PRODUCT  
SUPPORT  
BULLETIN #

135

43-74-0090 Chain Hook - 48-08-0250 Band saw table  
43-74-0110 Chain Hook - 48-08-0260 Band saw table

48-08-0250 Band Saw Table

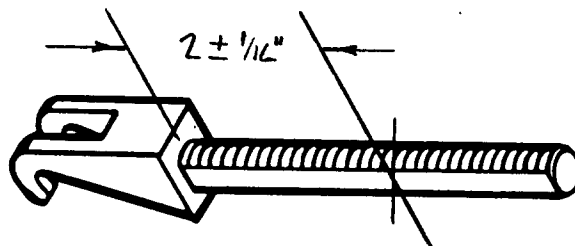
43-74-0090 chain hook for the 48-08-0250 band saw table is obsolete - no longer available.

43-74-0110 chain hook can be substituted for the 43-74-0090 hook, after shortening the threaded portion of the -0110 hook to 2 inches  $\pm 1/16$ ", as shown.
